UNITED STATES PATENT AND TRADEMARK OFFICE

APPLICATION NO.	FILING DATE	FIRST NAMED INVENTOR	ATTORNEY DOCKET NO.	CONFIRMATION NO.
10/776,839	02/11/2004	Ludwig Busam	CM2725MQ	3030

Office Action Summary	Application No. 10/776,839	Applicant(s) BUSAM ET AL.	
	Examiner Jacqueline F. Stephens	Art Unit 3761

DETAILED ACTION

FIG. 17

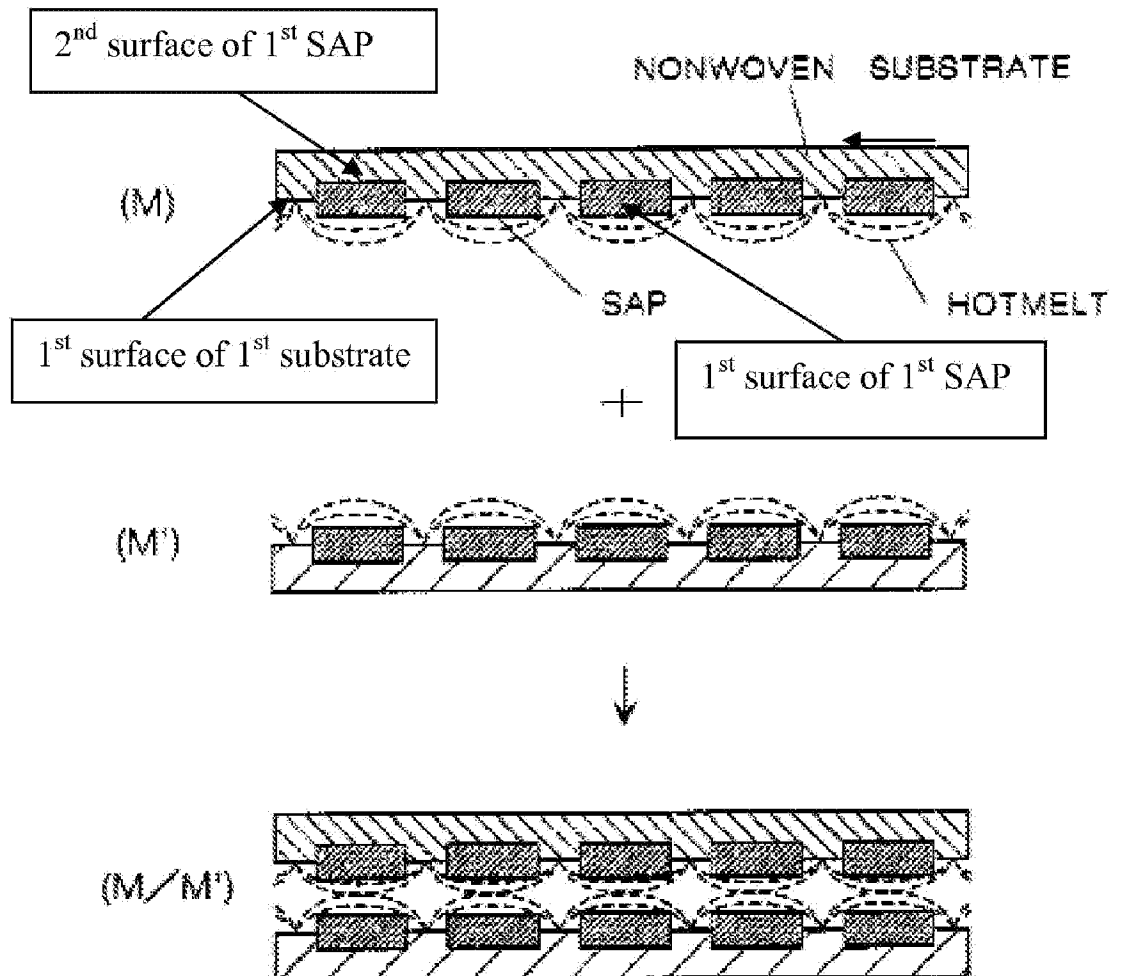
1. Applicant's arguments filed 12/29/08 have been fully considered but they are not persuasive. Applicant argues there is no teaching or suggestion in Suzuki of an absorbent core having two discontinuous layers of absorbent polymer material that are arranged in such a way that the absorbent polymer material of one layer faces the areas of junction of the other layer. However, the claims do not require the layers to be adjacent or directly face the areas of junction of the other layer. As broadly as claimed the second substrate layer M' faces areas of junction of the first substrate layer M (Figure 17).

not contact each other (abstract; ¶ 0042)(see annotated fig. 17, infra). As broadly as claimed the second substrate layer M' faces areas of junction of the first substrate layer M (Figure 17).

Regarding claim 2, Suzuki teaches that the thermoplastic material includes a hot melt adhesive (abstract)(fig. 17).
